Soldier Creek Coal Company  
**HIDDEN VALLEY MINE**

Re: Interim Program Regulations  
Hidden Valley Mine  
ACT/015/022

TO: Ronald W. Daniels, Coordinator of Mined Land Development  
FROM: K. Michael Thompson, Engineering Geologist  
SUBJECT: Soldier Creek Coal Company  
Proposed Hidden Valley Mine  
Emery County, Utah  
ACT/015/022  
DATE: February 4, 1980

HIDDEN VALLEY MINE  
 PROPOSED MINE LAYOUT  
B-SEAM

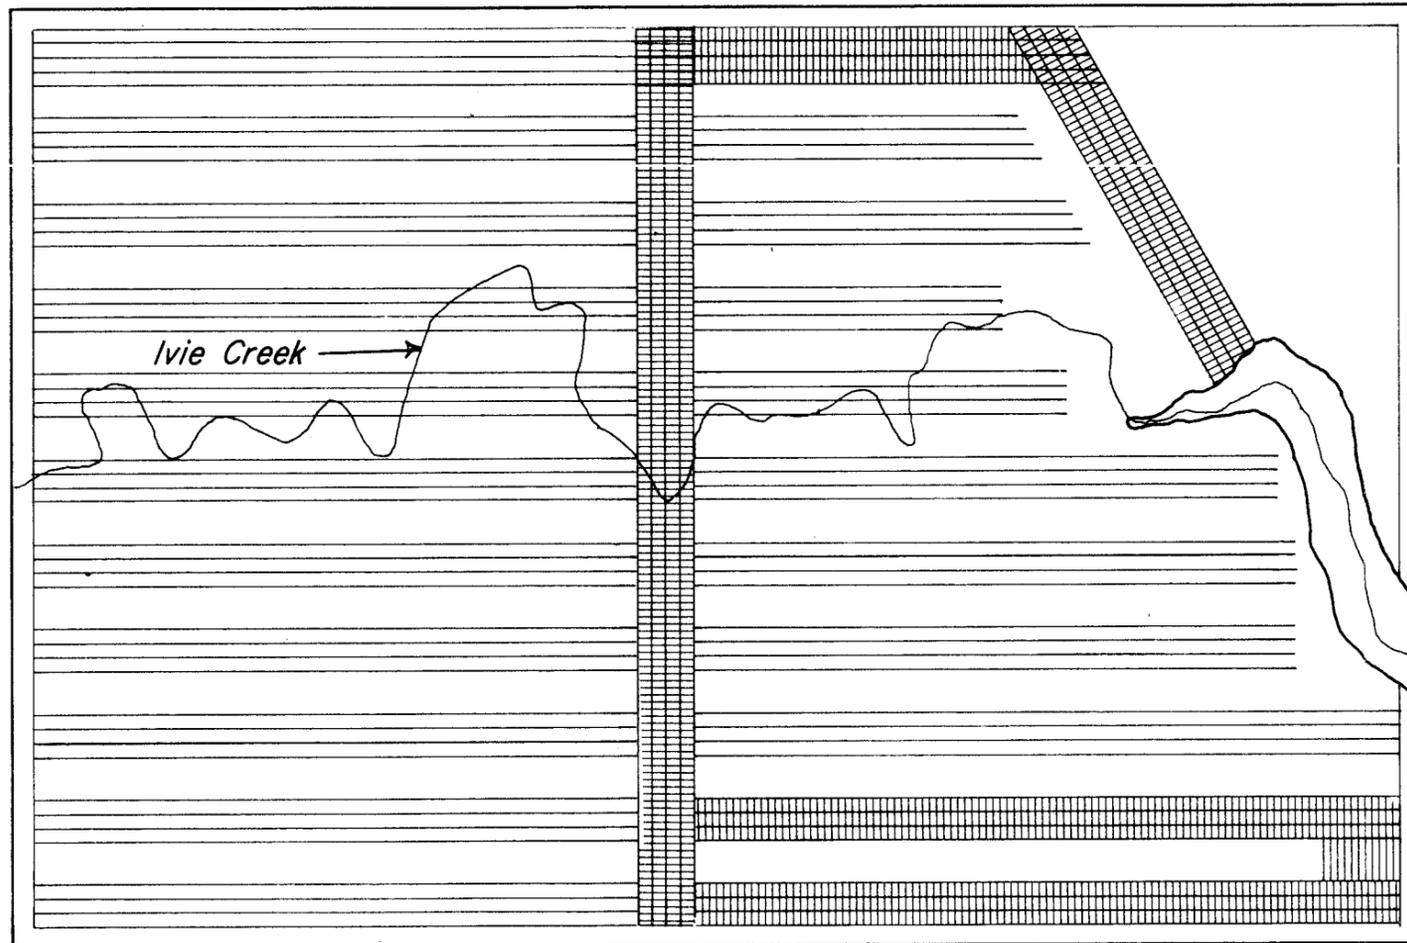
1. An amendment is needed stating which seam(s) will be mined and how mining development will progress, along with proposed time frames.

Three mineable seams exist at Hidden Valley Mine. They have been designated as the A, B, and C Seams in ascending order. Preliminary plans call for the systematic mining of all three seams. Multiple seam mining will be accomplished by the extraction of the upper seam preceding the lower seam.

The proposed mine layout and projected five-year development for the B and C Seams are shown in Figures 1 and 2 respectively. The proposed mine layout for the A Seam is identical to that of the B Seam.

Since the C Seam is mineable only on the western half of the property, initial development will begin in the B Seam. The C Seam will then become accessible via the B Seam development and a rock slope as indicated in Figure 2.

\* - Soil Sample Location

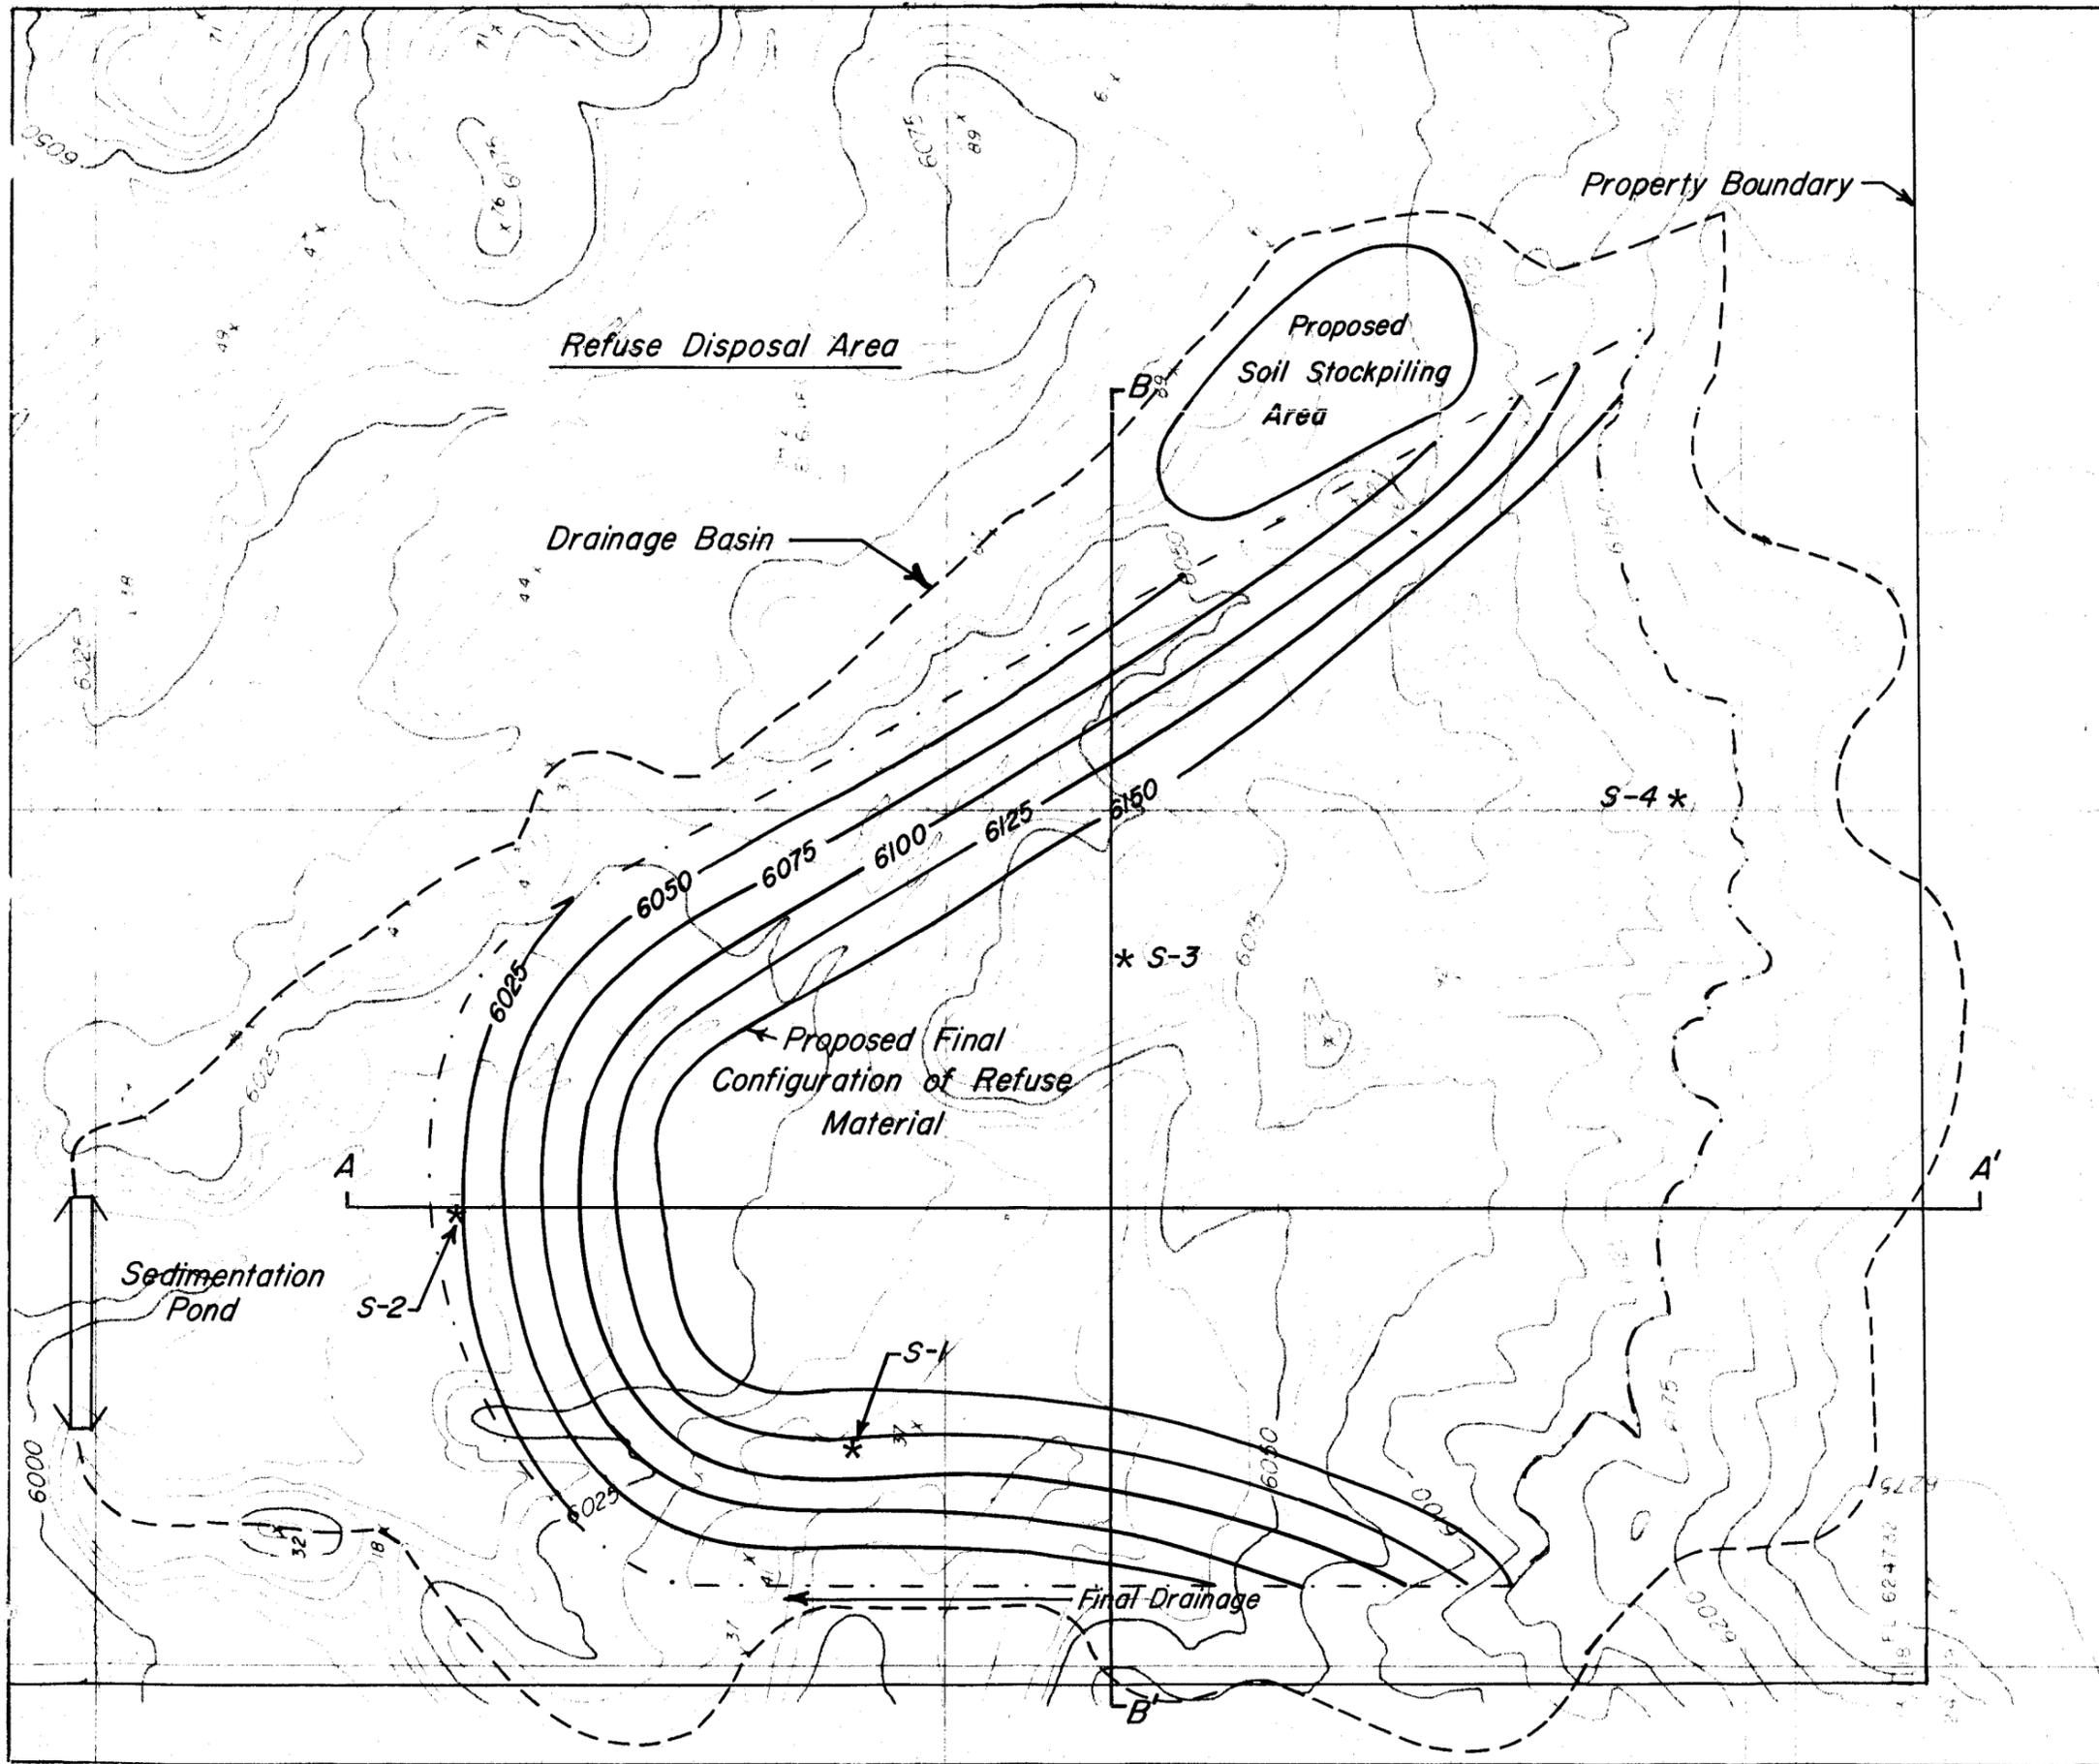
2. The following applies not only to the refuse disposal area, but also to all of the disturbed areas. Unless it is demonstrated by the applicant that alternative topsoil and surficial material is available; the borrow area is included in the permit application; and insufficient topsoil and unconsolidated surface material is available on-site; the material must be removed, segregated, stockpiled and protected. Using the material for fill, or berms, etc. at the discretion of the operator can not be permitted. However, if it is demonstrated by the operator that the amount of topsoil and unconsolidated surficial material necessary for reclamation is stockpiled as required, the excess unconsolidated surficial material may possibly be utilized as proposed.

3. Pages 7 to 9 - Item 7.F. The reply does not adequately demonstrate the amount of surficial material present (or not present) and does not demonstrate the revegetation potential (or lack thereof) of the surficial material. Hidden Valley can not "reserve the right" to use the topsoil

Several soil samples have been taken within the refuse disposal area as indicated in Figure 3. Analyses of these samples presented in Table 1, indicate that the soil revegetation potential is generally favorable. Lime and pH are normal with potassium being adequate in all profiles. The sodium adsorption ratio is basically low for all samples. Low phosphorus values and soluble salts, especially in subsoils, may create moderate problems. The accumulation of salts may affect sensitive plants in dry periods. However, it is believed that many species would not be seriously affected.

It is proposed that prior to initiating any development within the refuse disposal area, that a 6-inch layer of surface soil be removed, segregated, and designated as topsoil. This is in accordance to 30 CFR 817.22 (c). This amount will be removed to the extent possible using conventional equipment. Topsoil removed will be stockpiled and stabilized in a designated area until required for reclamation (see Figure 3).

TITLE: CROSS SECTIONS - PROPOSED REFUSE DISPOSAL

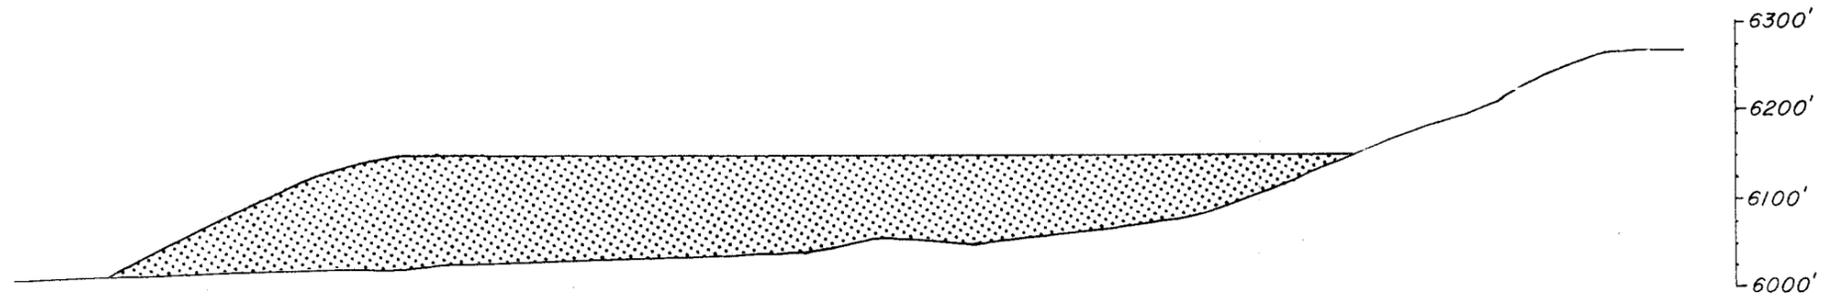
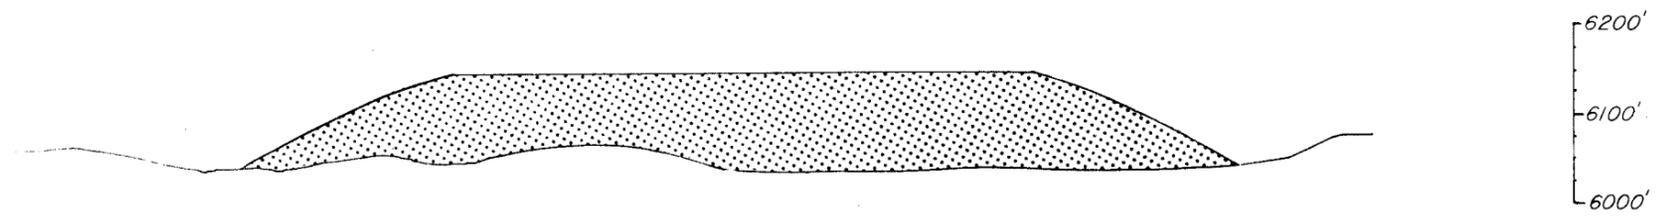
1. Pre-mining and post-mining profiles of the refuse disposal areas should be submitted.

See Figures 3 and 4.
